**SUBMITTAL TO THE BOARD OF SUPERVISORS
COUNTY OF RIVERSIDE, STATE OF CALIFORNIA**

SUBJECT: TRANSPORTATION AND LAND MANAGEMENT AGENCY/TRANSPORTATION:
Approve Addenda to the Plans and Specifications, Accept the Low Bid and Award the Contract for the Construction of the Clinton Keith Road Construction Project-Phase 3, Leon Road to State Route 79 including the French Valley Creek Bridge in the City of Murrieta and French Valley Area; and the Max Gilliss Blvd and Leon Road Resurfacing Project, Max Gilliss Blvd: Leon Road to Winchester Road, and Leon Road: Clinton Keith Road to Baxter/Jean Nicholas Road in the Community of French Valley, District 3. [\$23,659,634 Total Cost - Local Funds 100%] (Companion Item to MT No. 17919)

Addendum No. 2
Clinton Keith Rd Construction Project – Phase 3
Leon Rd to State Route 79 Including
French Valley Creek Bridge
In the City of Murrieta and French Valley Area
Project No. B2-04723

and;
Max Gilliss Blvd and Leon Rd Resurfacing Project
Max Gilliss Blvd: Leon Rd to Winchester Rd
Leon Rd: Clinton Keith Rd to Baxter/Jean Nicholas Rd
Community of French Valley
Project No. D1-0054

SHEET No.
G-1
 SHEET 17 OF 108

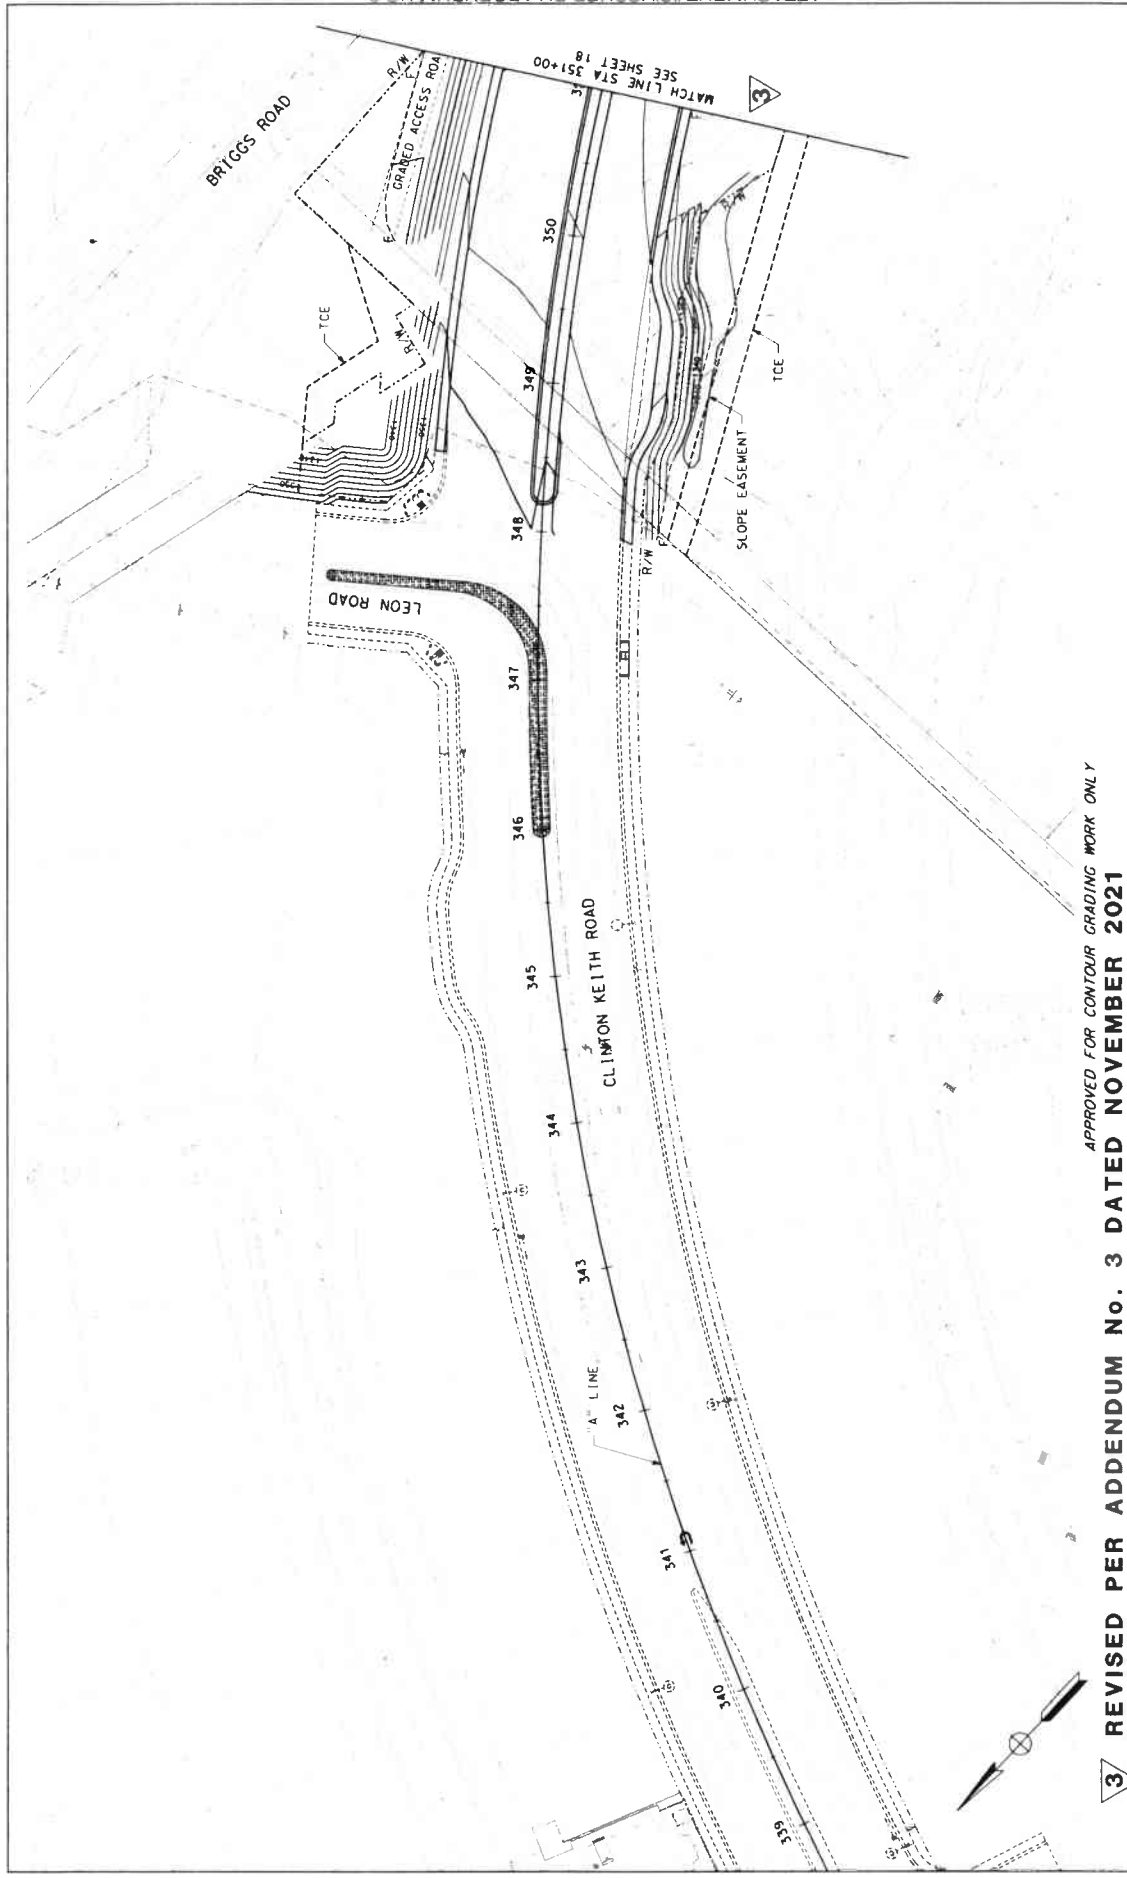
3 REVISED PER ADDENDUM NO. 3 DATED NOVEMBER 2021 APPROVED FOR CONTOUR GRADING WORK ONLY

SHEET No. D-1
25 of 108

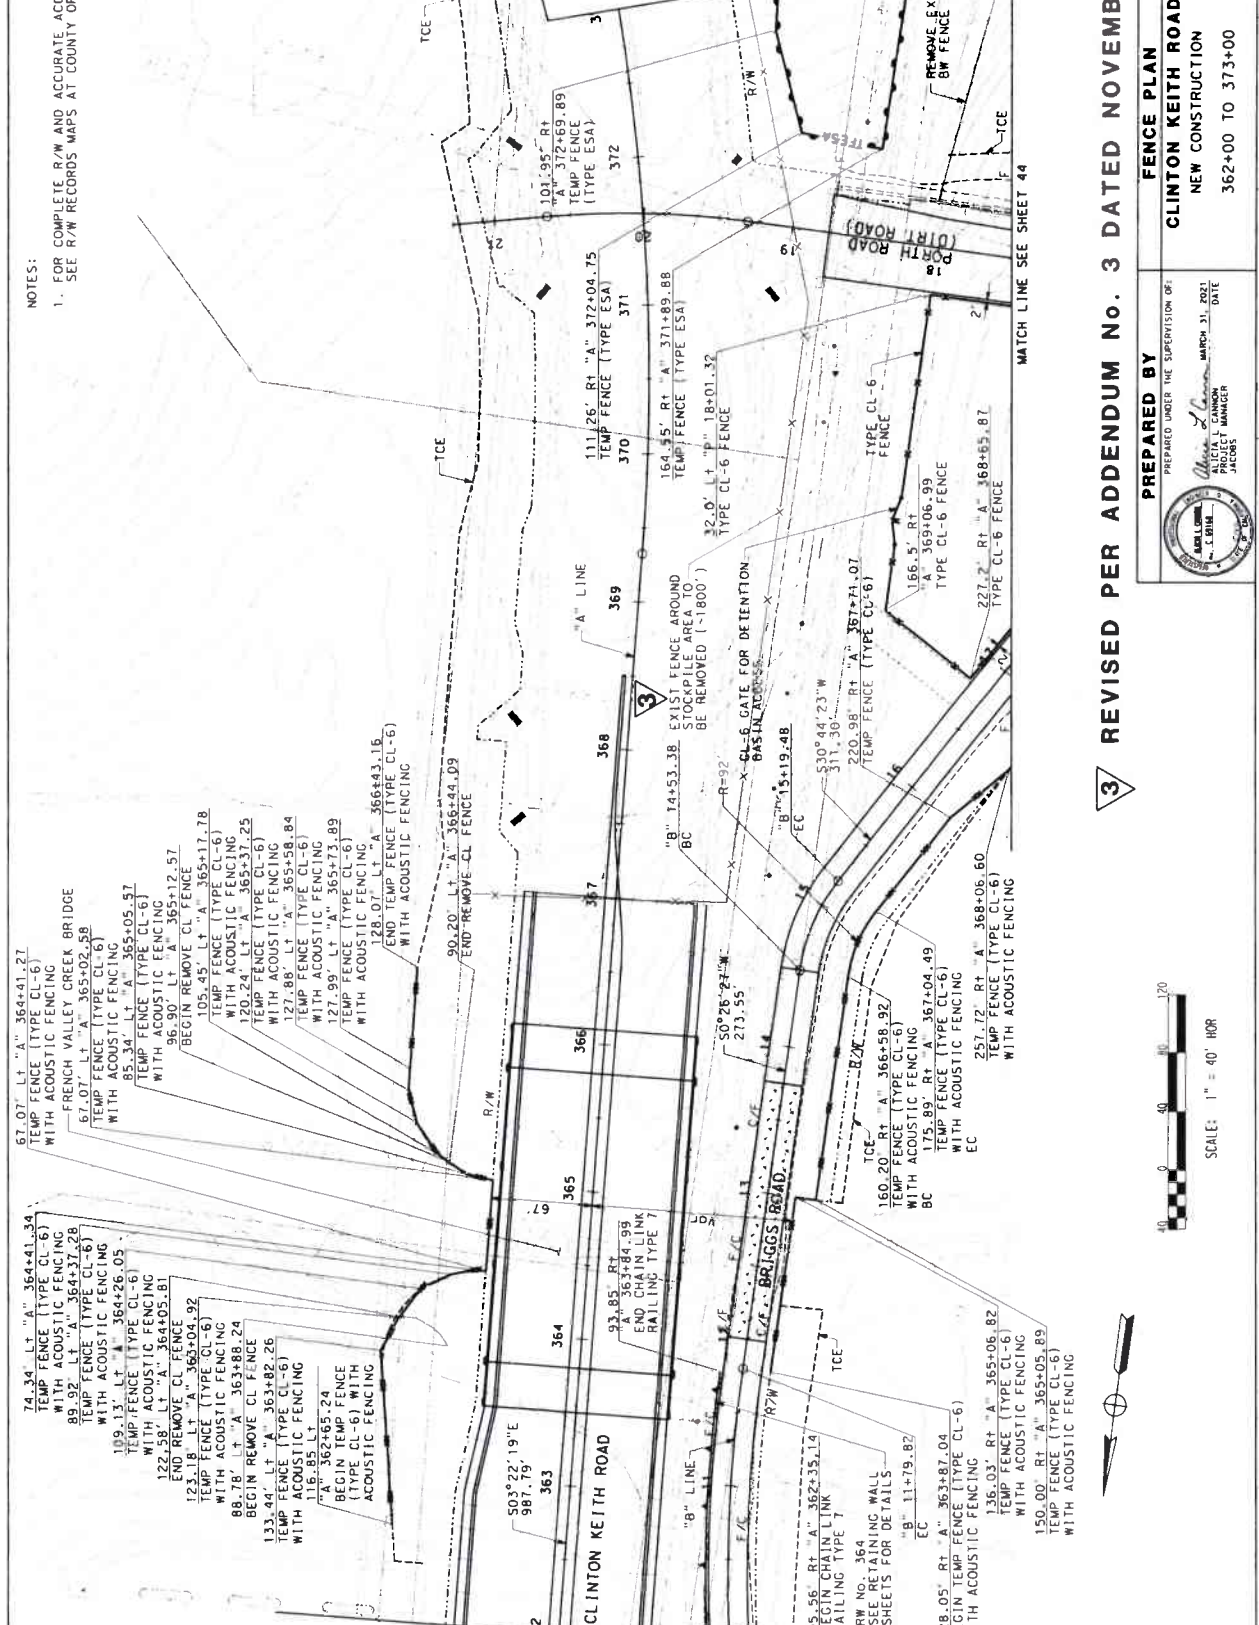
- 49 CONSTRUCT HEADWALL PER CALTRANS DETAIL D898.
- 50 CONSTRUCT MH1 PER RCGC AND MCD 51D MH251, PER PROFILE.
- 51 INSTALL RSP PER DETAIL, SHEETS 32, 33 & 34.
- 52 CONSTRUCT G1 INLET PER CALTRANS STD PLANS DT2B. SEE GLD CONNECTION DETAIL "B", SHEET 31.
